## Certificate of Appropriateness Case Report

HEARING DATE: SEPTEMBER 21, 2016

*Filing Date:* December 3, 2015  
*Case No.:* **2015-012830COA**  
*Project Address:* **1133 TENNESSEE STREET**  
*Historic Landmark:* Dogpatch Landmark District  
*Zoning:* NCT-2 (Small-Scale Neighborhood Commercial Transit) Zoning District  
40-X Height and Bulk District  
*Block/Lot:* 4172/028  
*Applicant:* Robert Noelke  
1074 Tennessee Street  
San Francisco, CA 94107  
*Staff Contact* Richard Sucre - (415) 575-9108  
richard.sucre@sfgov.org  
*Reviewed By* Timothy Frye – (415) 575-6822  
tim.frye@sfgov.org

**1 FRONT/WEST ELEVATION - EXISTING**  
1/4" = 1'-0"

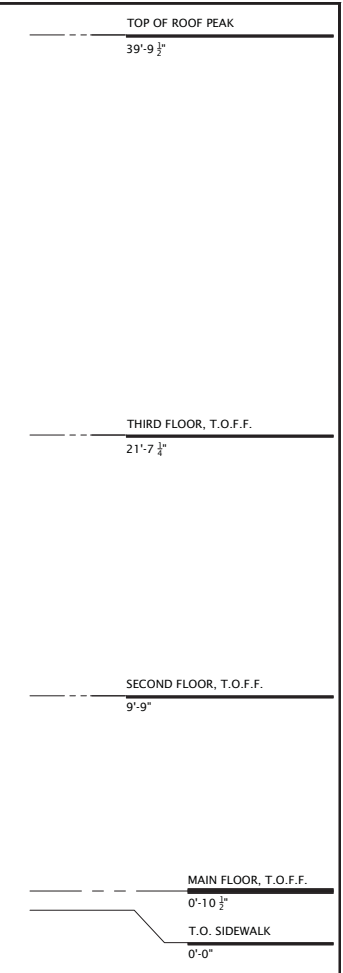
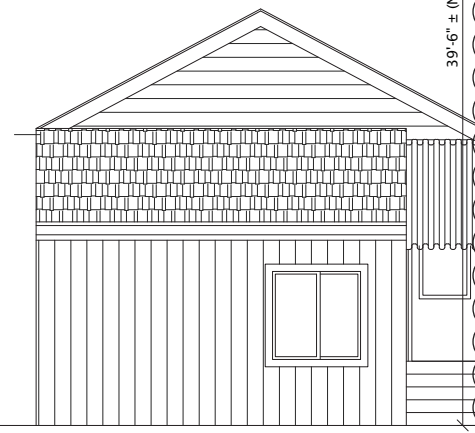
The reconstructed front entry stair maintains the alignment and location of the existing non-historic stair, which appears to be in the same alignment and orientation as the historic stair, as noted by entry configuration and other nearby properties that also have similar types of staircases. The replacement of the stair and handrails would remove a non-historic feature and introduce a more compatible element on the exterior façade. To ensure that the work is performed in conformance with Article 10 of the San Francisco Planning Code and Secretary of the Interior' Standards for Rehabilitation, Department staff has included a condition of approval for material samples of the stair tread and risers and handrails, as well as the other exterior materials, and construction details for the new stair and handrail.

2. Prior to approval of the Site Permit, the Project Sponsor shall submit a materials board to Planning Department Preservation staff to verify the final material choice and finish of all of the proposed exterior materials. The materials board shall demonstrate the range of finishes of the proposed exterior materials, as well as paint color.
3. Prior to approval of the Site Permit, the Project Sponsor shall submit additional information on the design and dimension of the new entry stair and handrail. The new stair and handrail shall be consistent with the other historic entry stairs evident with the landmark district.

**4 REAR/EAST ELEVATION - PROPOSED**  
1/4" = 1'-0"

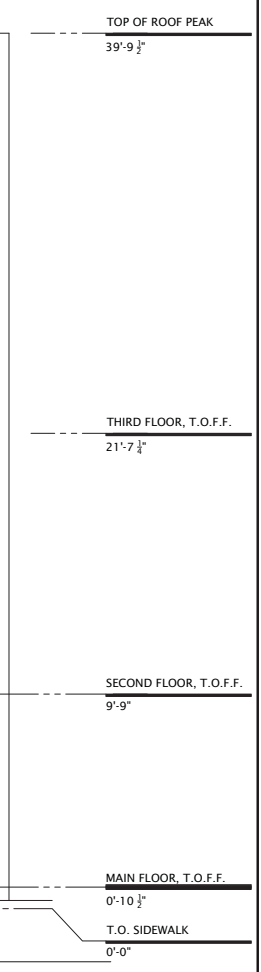
*At the rear, the new horizontal rear addition is clearly differentiated from the historic mass of the original residence, as noted by the roofline, overall massing and vertical trim. The new addition would replace an existing non-historic addition currently located at the rear of the existing residence. The new addition and rear façade alterations are compatible with the subject property's overall historic character, since the new work is occurring on a rear and non-visible façade, the*
